Product Support Bulletins

May 1974 to September 2000

These Support Bulletins have changes that were not necessarily made before the manuals were printed.

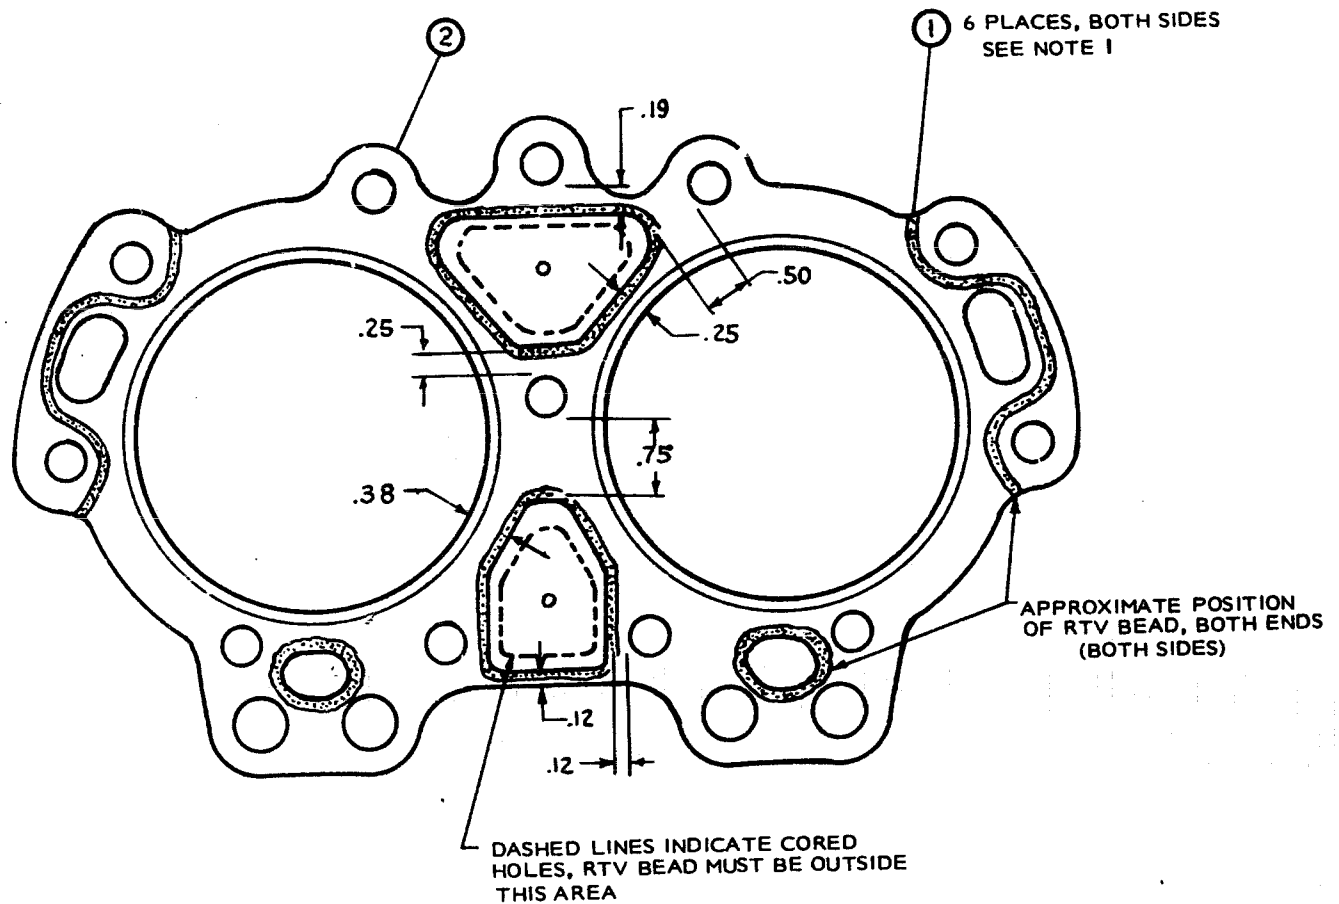
There are a number of RTV sealants on the market. We recommend White "RTV" Sealant such as Dow-Corning "Silastic" RTV Silicone Rubber Adhesive Sealant #732 or General Electric White "RTV" Sealant.

When applying Sealant, Bead should be .03-.06 thick on both sides of head gasket. The "RTV" Sealant may also be applied to the finished surface of the block and just one side of the gasket.

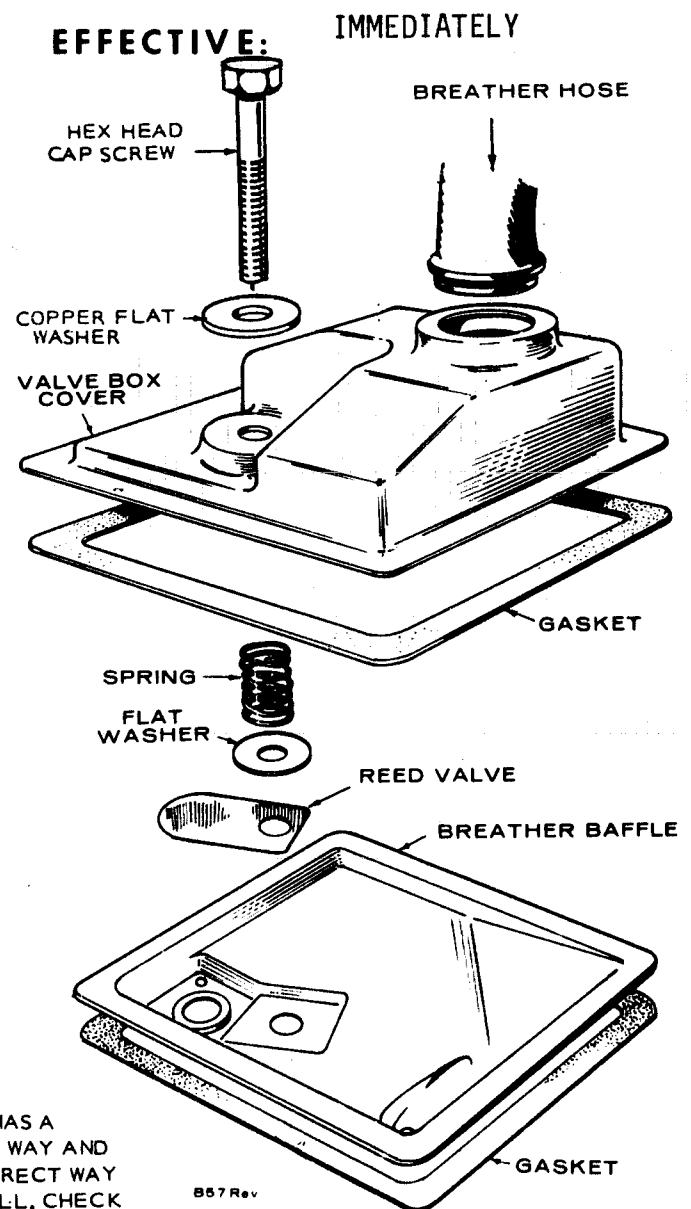
When investigating high oil consumption complaints on older models; check the breather valve to be sure it has been properly assembled.

In some older models it is possible that an extra flat washer is installed between the breather baffle and reed valve.

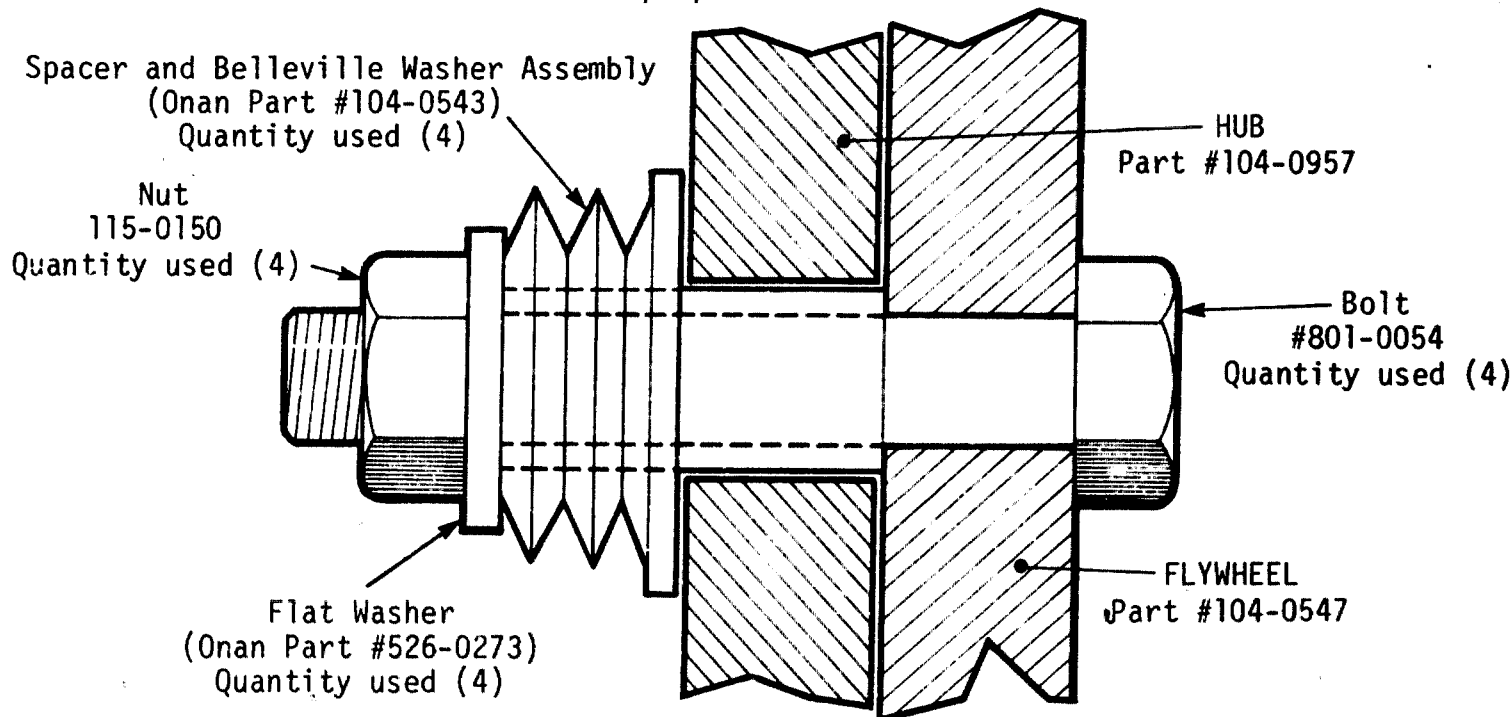
Flywheel hub (Onan Part #104-0546) is Obsolete. The New replacement flywheel hub is available under Onan Part #104-0957.

This new ductile iron hub provides added strength and increased clearance. It can be further identified by the number 170-3213 stamped in the casting itself. In cases of crankshaft breakage you must use this new replacement hub to correct this problem.

See illustration below for proper damper assembly.

Figure 2
CCKA, CCKB
BLOWER HOUSING

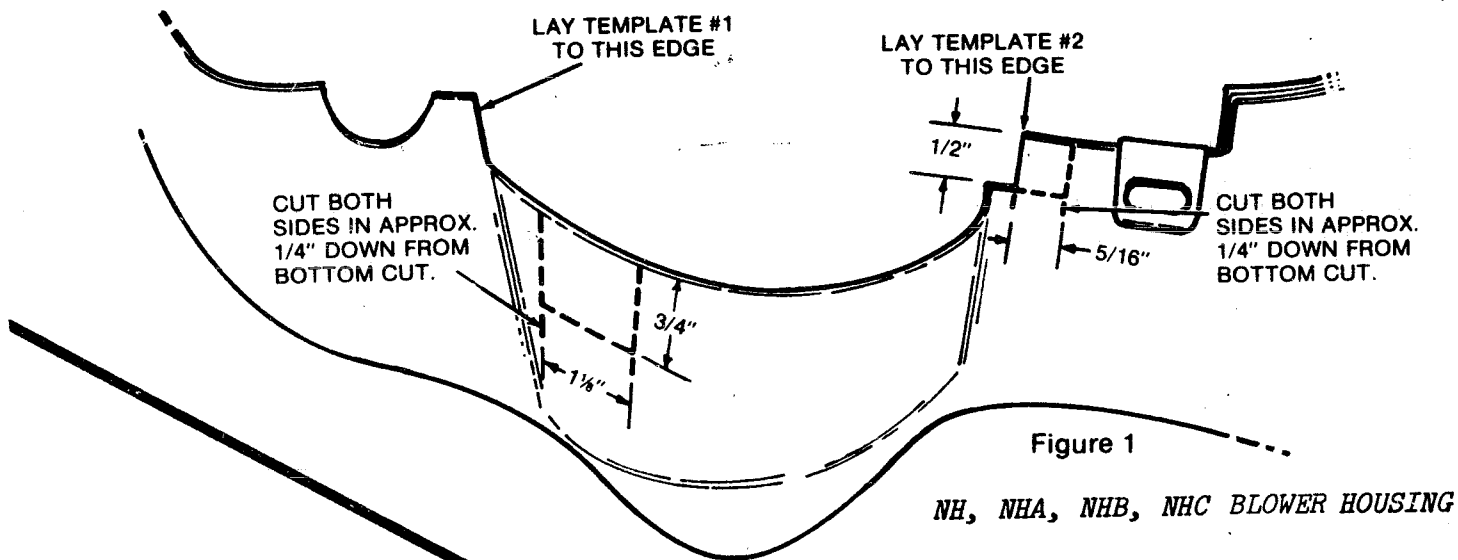
Slight modification to the blower housing is required in order to use the 191-1052 starter on the above engine models. This procedure and all necessary instructions are shown on Instruction Sheet E221. See attached copy for reference.

1. Remove blower housing.
2. Lay blower housing on bench or table so that grill-work is face down.
3. Cut out template #1 and lay edge marked with arrow along corner as shown in diagram.
4. Mark the outline of the cuts to be made.
5. Using a hacksaw, cut along the two parallel lines. (Be sure the parallel cuts are made far enough down so that the metal can be bent for making the final cut). See Figure 1.
6. Bend back metal along remaining line to allow for cutting.
7. Cut along remaining line to remove metal piece.
8. For template #2, place along edge indicated in figure. Mark lines and cut.
9. File along edges if necessary.

**ORIGINAL GOVERNOR
CONFIGURATION**

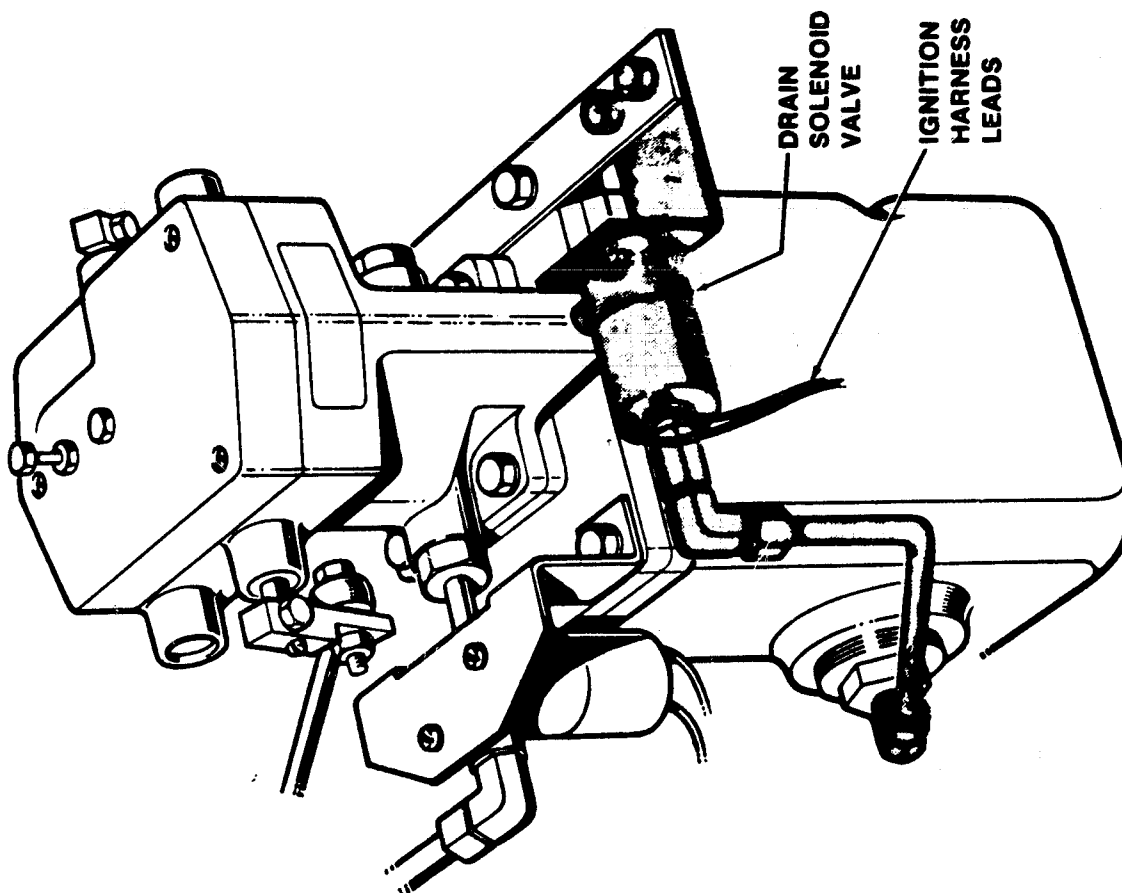
**NOTE: REMOVE ITEMS THAT ARE
SHADED.**

FIGURE 1. FRONT MAIN BEARING AND CRANKSHAFT RADIUS DO NOT MATCH RESULTING IN A PRE-LOAD CONDITION AND NO ENDPLAY

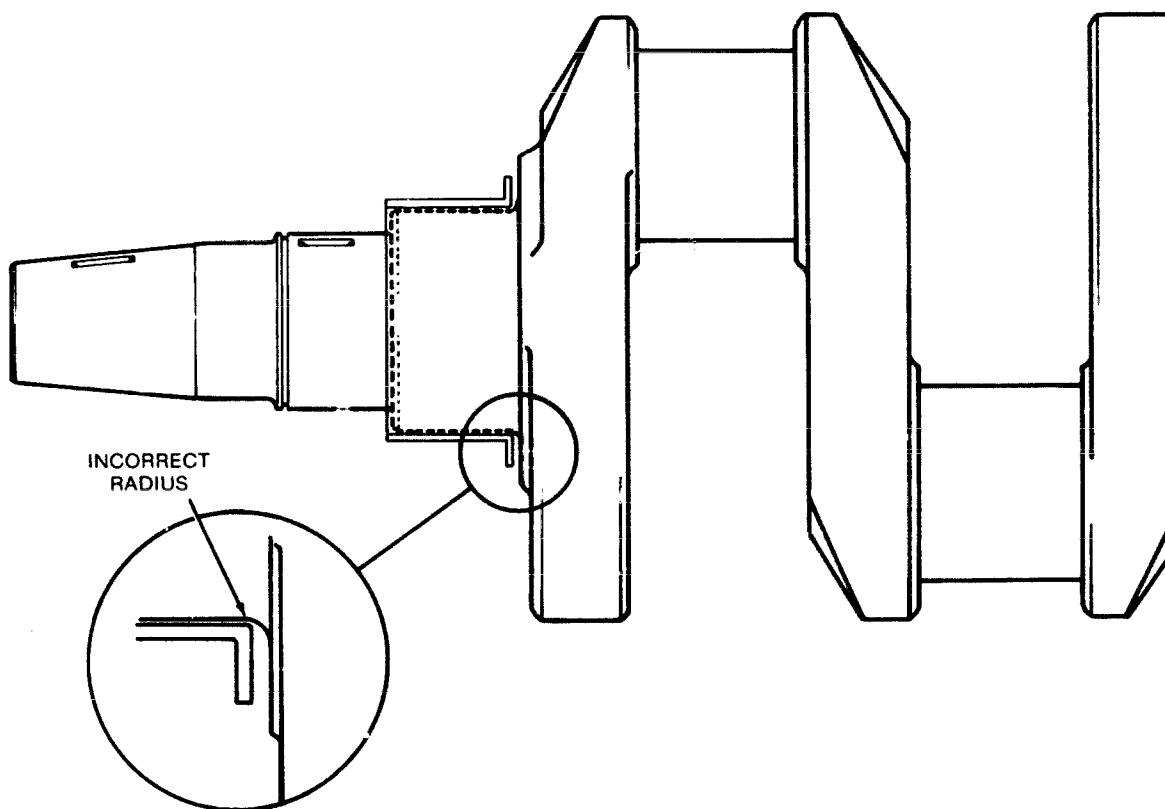
Field reports indicate that some of the above replacement front main bearings have an incorrect radius as shown in Figure 1. If a defective bearing is installed, the crankshaft radius will NOT match-up, resulting in a pre-load condition and no end play.

FIGURE 2. FRONT MAIN BEARING AND CRANKSHAFT RADIUS MATCH ALLOWING PROPER ENDPLAY.

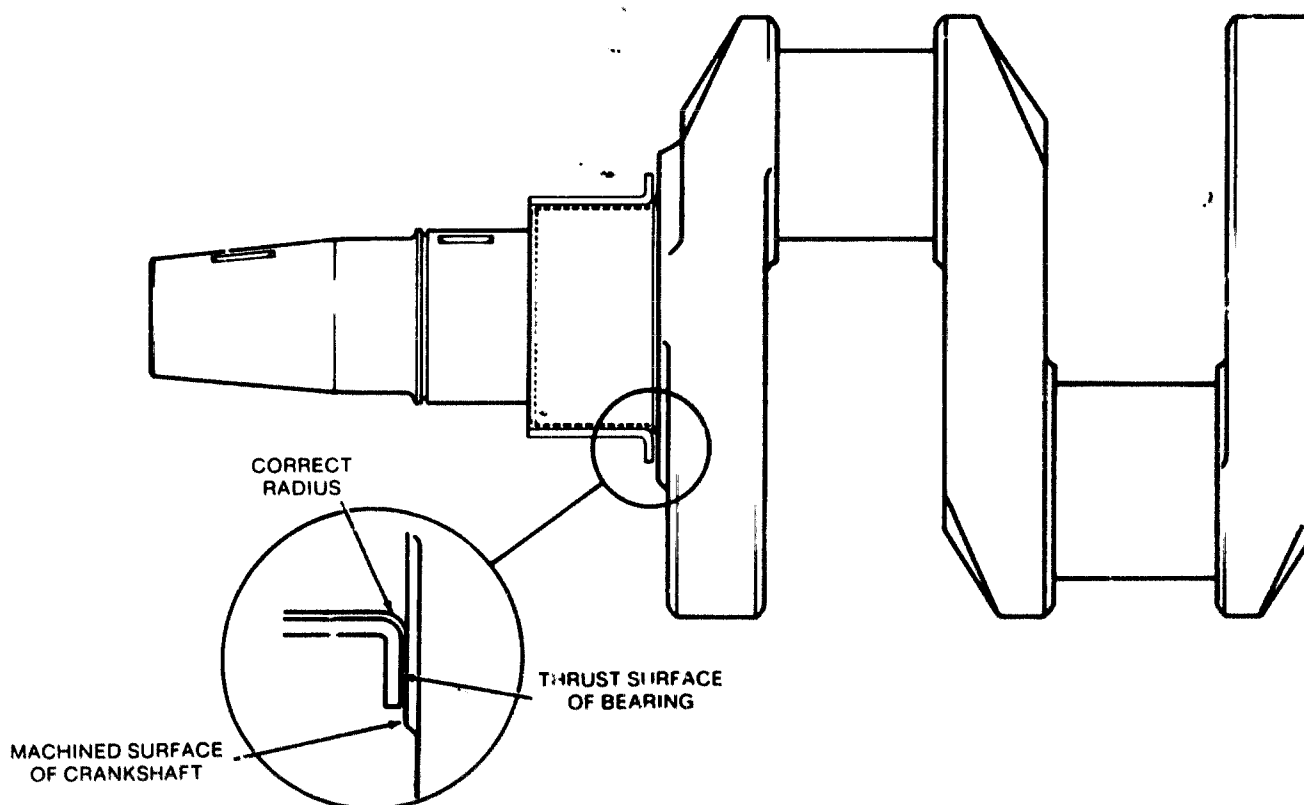
Check your stock of standard size bearings, both visually and by sliding the bearing onto any "B" or "N" series crankshaft. Proper radius as shown in Figure 2 will allow the thrust surface of the bearing to touch the machined surface of the crankshaft.

FIGURE 1. Original Transfer Switch Microswitch Configuration

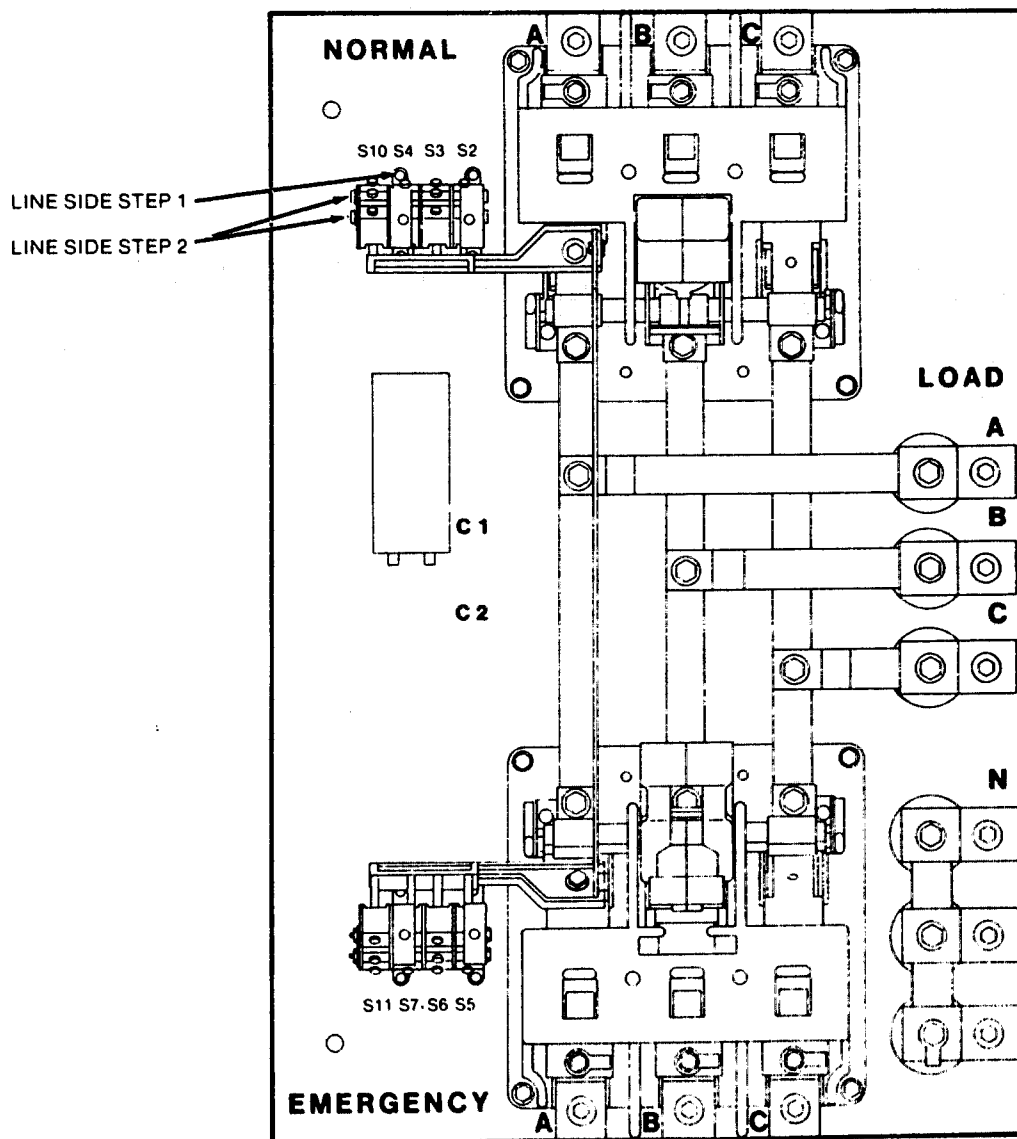
On certain transfer switches manufactured for Western Electric, we have encountered some auxiliary contact problems which may require changing the physical location of certain microswitches. These switches are designated as S10 and S11 or S8 and S9. Regardless of switch designation, the physical location is always the same. See Figure 1 on page 2.

1. Remove the four mounting screws which secure the microswitch mounting brackets to the transfer switch base.
2. Remove the two outside nuts which hold the double pole, double throw outside microswitch to the outside mounting bracket. See Figure 1.

FIGURE 2. Modified Microswitch Configuration

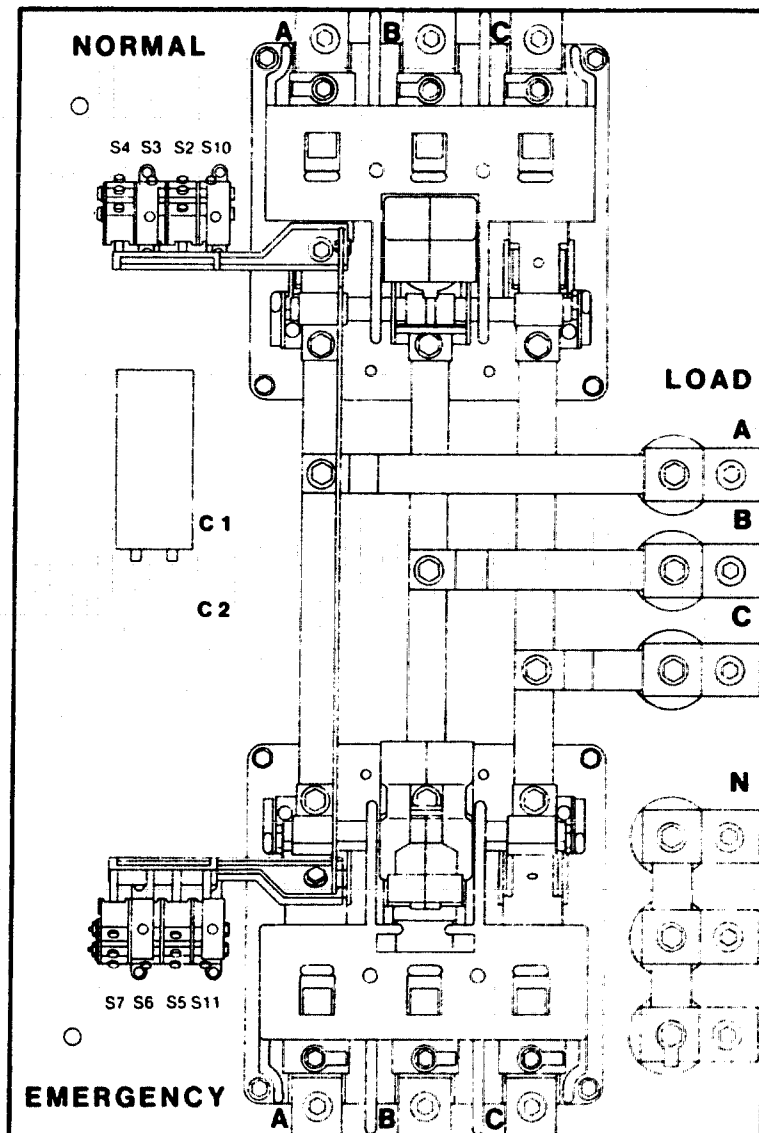
4. Reassemble microswitches to mounting brackets by repositioning the double pole, double throw microswitch (removed in step 2)to the inside position(closest to the power pole)as shown in Figure 2. All three* remaining microswitches must be moved over one position toward outside(away from power pole). Switch barriers(insulators) must be reassembled on both sides of each microswitch during reassembly. Do NOT tighten microswitch mounting screws.

Refer to Figure 2 on page 3 which shows the modified microswitch configuration.

FIGURE 1. FACEPLATE

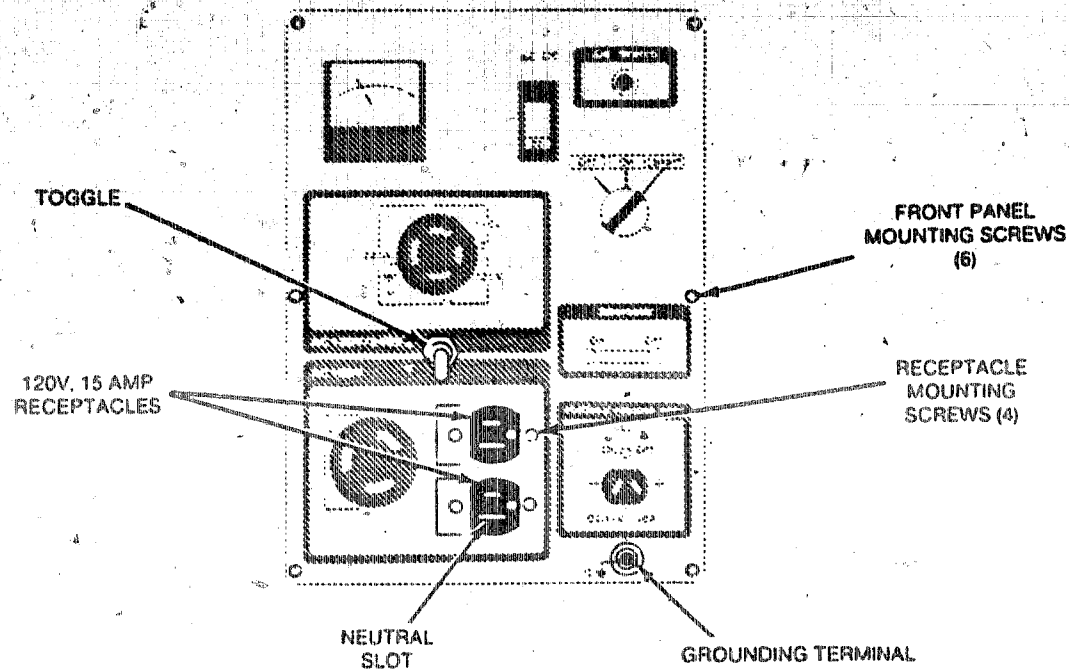
FIGURE 2. BEFORE

FIGURE 3. AFTER
